Staff Proposed Amendments to Landscaping and Bufferyards

14. Section 39.03.016.e.3.B - Parking Bufferyard Standards

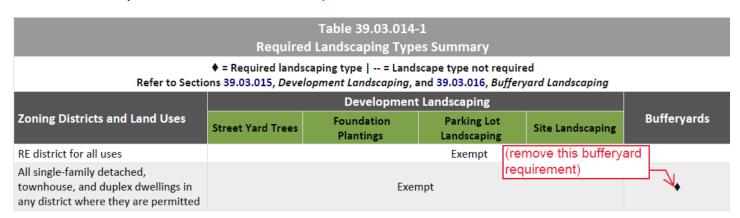
- **a. Current Language:** *Composition.* A parking area buffer shall be composed of one of the following screening devices that are two feet tall:
- **b. Proposed Revision:** *Composition.* A parking area buffer shall be composed of one any combination of the following screening devices that are two feet tall:

24. Section 39.03.015 - Development Landscaping

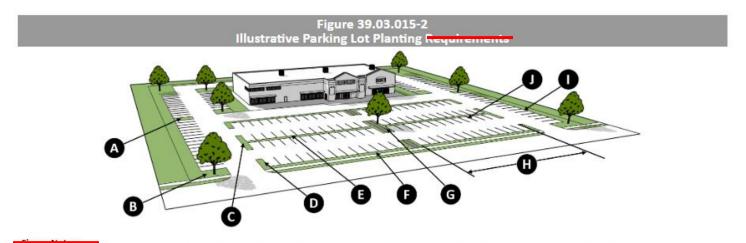
b. Proposed Revision: f. Contextual Landscape Requirement. Where an infill project is constructed on property zoned Industrial Park (IP), Light Industrial (LI), or General Industrial (GI) and the property is not adjacent to or across from any residentially zoned property, the infill site may match the landscape area coverage percentage and planting materials density on the average of those developed neighboring properties.
